Process Sheet

Customer : CC-DAR01 Dart Aerospace Ltd.	Drawing Name : REWORK
Job Number : 33464	
Estimate Number : 10804	
P.O. Number : N/A	Part Number : D25763
This Issue : 11/07/2007 S.O. No. : N/A	Drawing Number : D2576-3
Prsht Rev. : NC	Project Number : N/A
First Issue : N/A	Drawing Revision : N/A
Previous Run : 00015	Material : N/A
Written By : 	Due Date : 27/07/2007
Checked & Approved By : 	Qty: 100 Um: Each
Comment :

D2576-3 RE-WORK

From: Marc Bellavance [mbellavance@dartaero.com]
Sent: July 11, 2007 8:36 AM
To: 'L Lacelle'
Subject: D2576-3 Step Re-work
Attachments: D2576-3ReWork.pdf

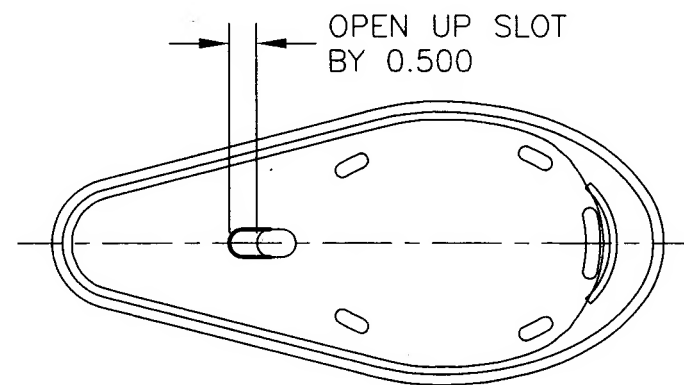
OPEN UP 0.50" WIDE SLOTS PER ATTACHED

Here are the instructions for the D2576-3 Step re-work:
Open up 0.50" wide slot as per attached sketch.
